BH/AC
12710
15 August 2016

Ms Carolyn McNally
Secretary
Department of Planning and Environment
33 Bridge Street
SYDNEY 2000

**RESPONSE TO SUBMISSIONS
SECTION 96 (MOD 2) TO CONCEPT PROPOSAL (SSD_5878)**

Figure 1 – Comparison of North Plot changes

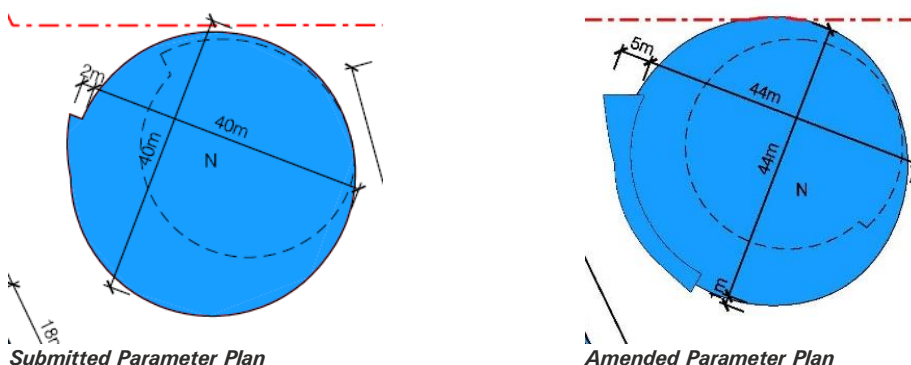
Minor amendments to the Parameter Plans are also proposed to those which were publicly exhibited. These changes respond to amendments made to the North Plot detailed building design as a result of design development and further collaboration with Council on the proposed library. **Figure 1** below illustrates the changes proposed to the North Plot within the Parameter Plan since public exhibition.

The proposed amendments to the North Plot relate to the extension of the wrapping stair on the western side of the building, as well as a widening of the Plot to account for the 'shifting' nature of the floor plates. These detailed changes will be further reflected in the Response to Submissions Report for the North Plot State Significant Development Application (SSD 7021).

Figure 2 – Section of the Boulevard

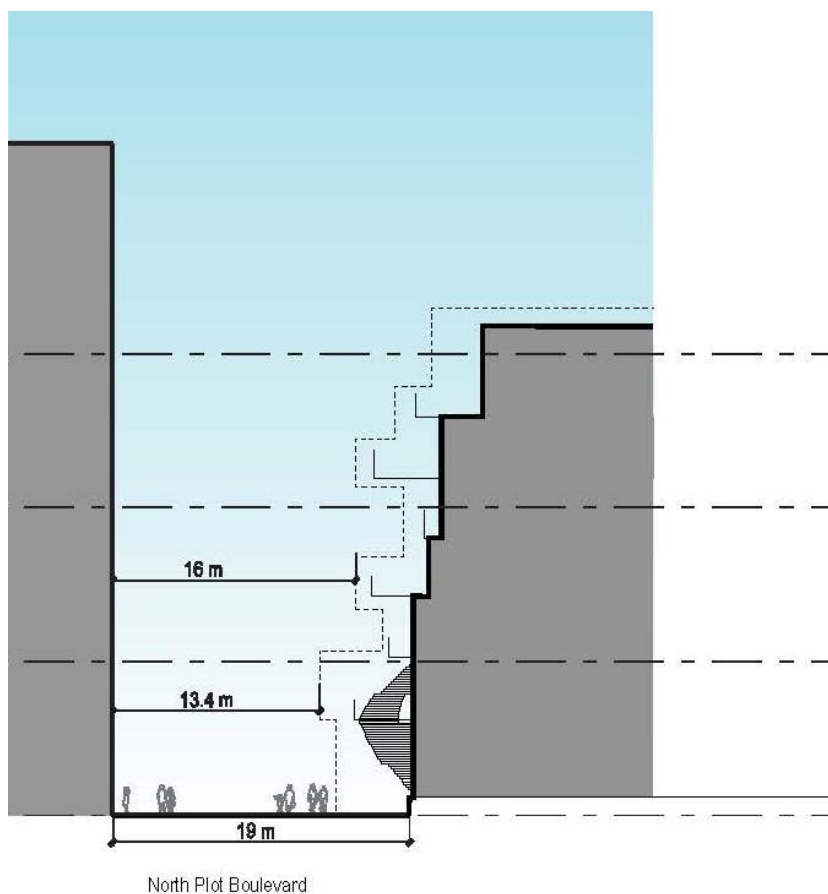
The Department has requested clarification on whether the detailed North Plot building design will be consistent with the Design Guidelines in relation to encroachments into the Boulevard. It is clarified that the Design Guidelines have been superseded in part with new Design Guidelines related to the reimagined North Plot.

Additional sections have been included in the Design Report (refer to **Attachment B**), reflecting the expected separation of the North and North West Plots. The relevant section is provided at **Figure 2** below.

As illustrated in **Figure 2**, the expected encroachments of the detailed North Plot building design into the Boulevard are minor and will still enable unrestricted pedestrian access and sightlines. The expected encroachments, which comprise a stair case at the lower levels and timber battens at the upper levels, will provide an interesting interface with the Boulevard and one that is highly articulated and lightweight. It is worth reinforcing in the context of these further refinements to the parameter plan that the north Plot building is of a public/civic nature.

The refined North Plot Parameter Plan retains a 19 metre separation to the North West Plot (effective width of Boulevard), except with the following flexibility:

A 500mm articulation zone is presumed around all building perimeters to allow for architectural detailing and expression (non-habitable space)

Minimum 19m plot separation at ground/ lower level reducing to:

- 13.4m at public stair/ canopy
- 16m at upper levels
